## **AMENDMENTS TO THE DRAWINGS**

## **REMARKS**

Fig. 2

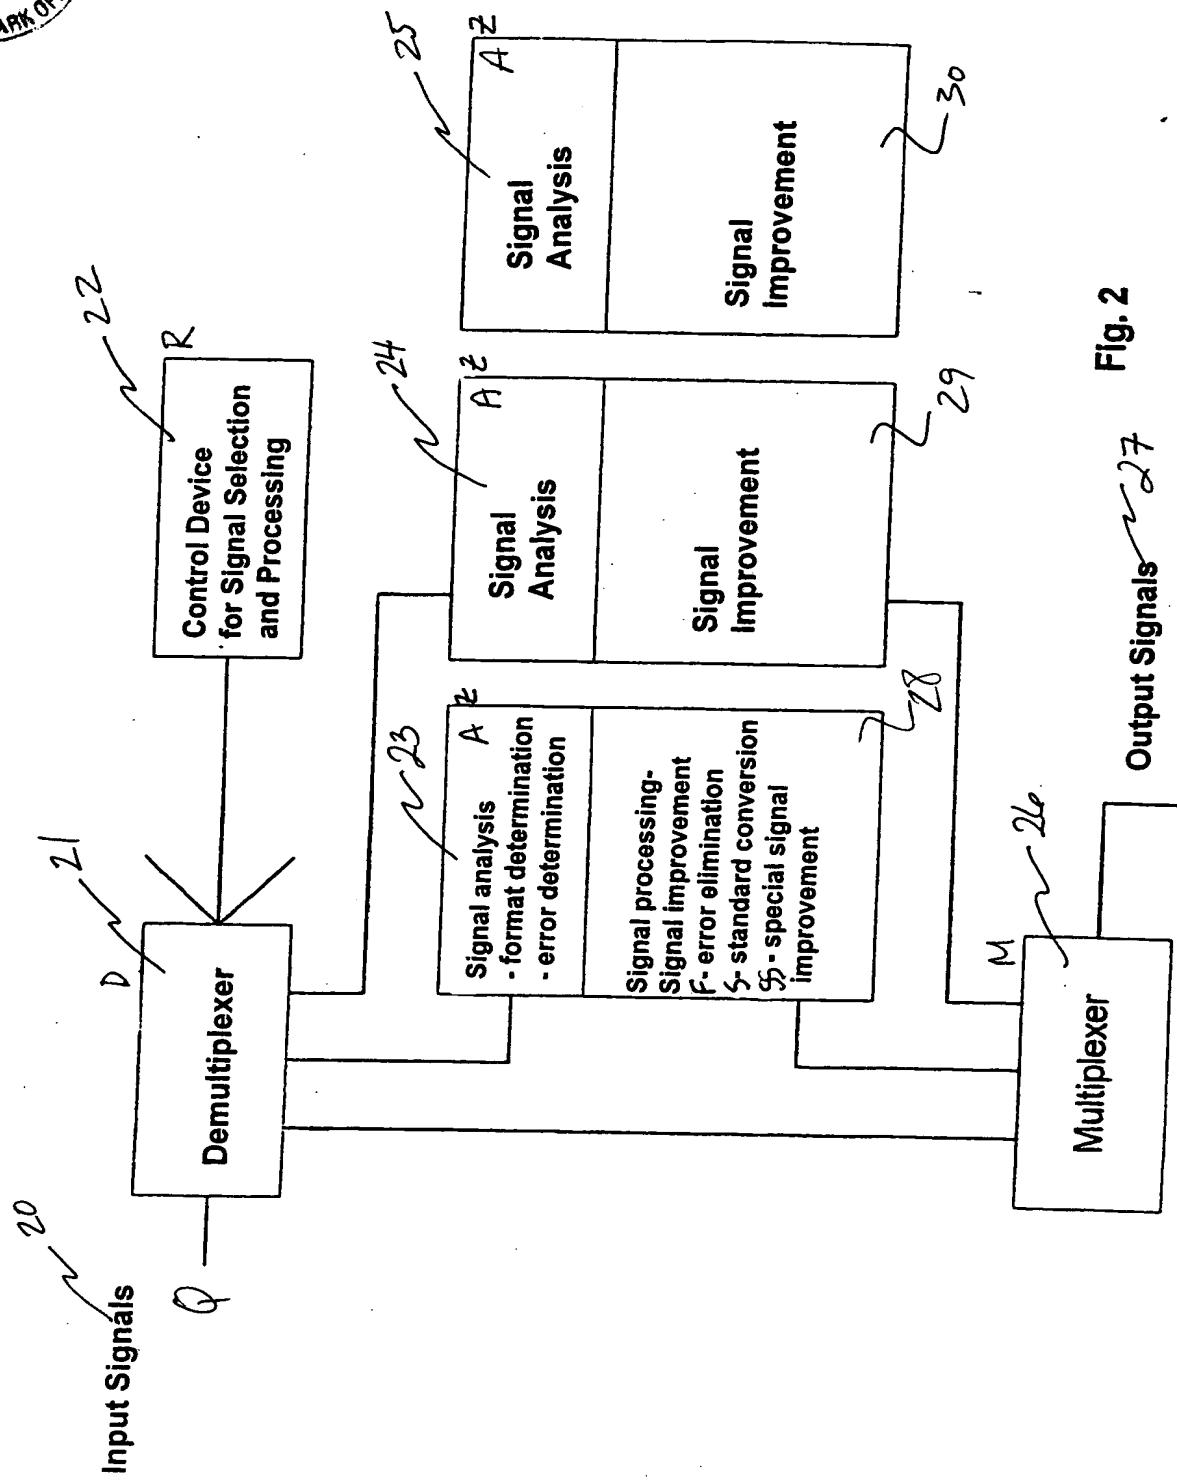
Figs. 1 and 2 were rejected for not having reference numerals. In accordance with the Examiner's request, Applicants have amended Figs. 1 and 2 to have reference numbers and have submitted herewith those Figs. for acceptance by the Patent Office. Accordingly, Applicants respectfully submit that the Figs. 1 and 2 are now allowable; and, withdrawal of the objections is respectfully requested.

The attached two sheets of drawings includes changes to Figs. 1 and 2. The [REPLACEMENT] sheet of Fig. 1 replaces the original Fig. 1 sheet; the [REPLACEMENT] sheet of Fig. 2 replaces the original Fig. 2 sheet. Figs. 1 and 2 are amended to include reference numbers.

The Specification was amended to include reference numbers in the description corresponding to the amended Figs. 1 and 2. No new matter has been added.
